IEEE P802.15
Wireless Personal Area Networks

Project	IEEE P802.15 Working Group for Wireless Personal Area Networks (WPANs)		
Title	Proposed changes to draft recommended practice		
Date Submitted	11 March, 2002		
Source	[David Cypher] and Robert Van Dyck [NIST] 100 Bureau Drive, STOP 8920 Gaithersburg, MD	Voice: Fax: E-mail:	[1 301 975 4855] [1 301 590 0932] [david.cypher@nist.gov] [1 301 975 2923] [1 301 590 0932] [robert.vandyck@nist.gov]
Abstract	This contribution proposes changes to the draft recommended practice version D04 March 1, 2002.		
Purpose	To make some changes to the draft now rather than in working group letter ballot comments		
Notice	This document has been prepared to assist the IEEE P802.15. It is offered as a basis for discussion and is not binding on the contributing individual(s) or organization(s). The material in this document is subject to change in form and content after further study. The contributor(s) reserve(s) the right to add, amend or withdraw material contained herein.

This contribution contains a list of proposed changes to the draft recommended practice version D04, March 1, 2002.

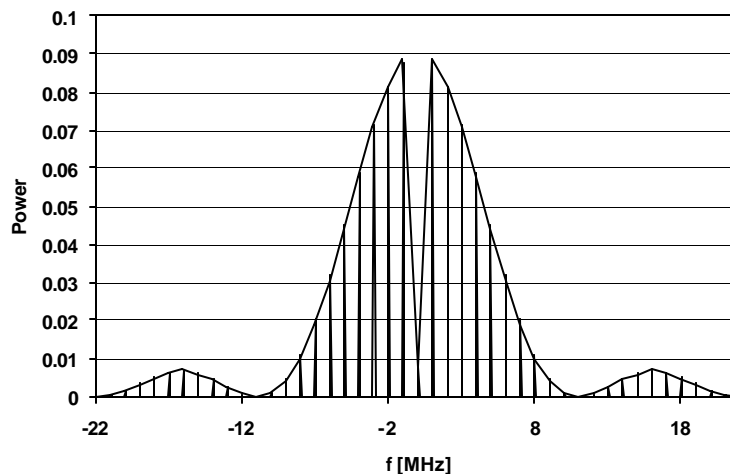
Requested change #4

Replaced Figure 7, page 22, “Power spectrum of the Barker code” (barkspec2.eps) with a new plot that more clearly shows the null at the center frequency.

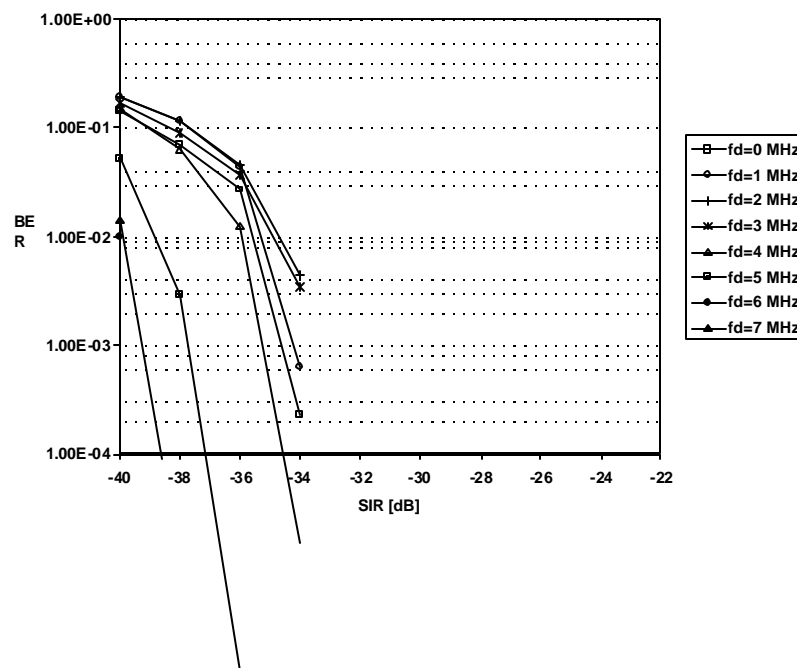
Replaced figure 13, page 29, (btcoh802bt2.eps) with a plot of the same data made in Excel.

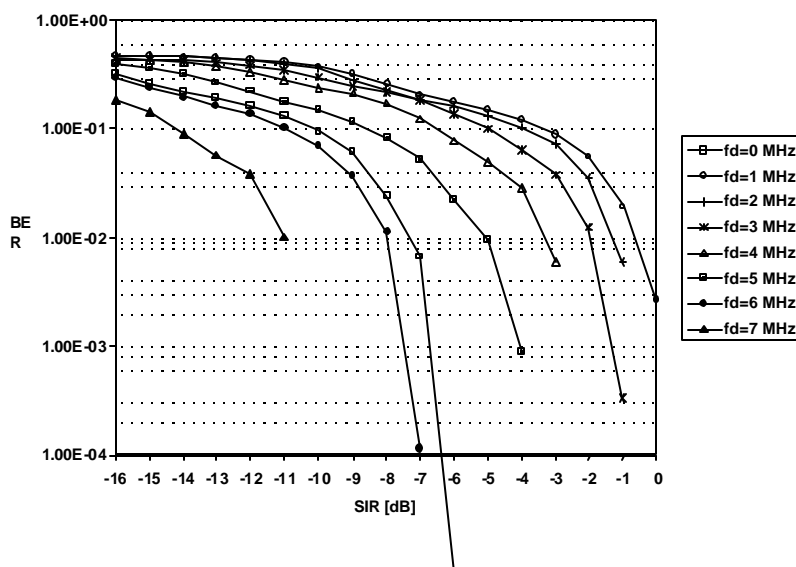
Add a new figure showing BER performance for IEEE 802.11 at 2 Mbit/s with Bluetooth interference to clause 5.4.3, after figure for 1 Mbit/s and before 11 Mbit/s.

Figure XXX shows the performance of the 2 Mbit/s 802.11b system in the same environment. The use of DQPSK modulation doubles the bit rate, but makes the BER worse by about 3 dB. However, the packet transmission time is decreased due to the higher bit rate, and, therefore, the system performance may improve.
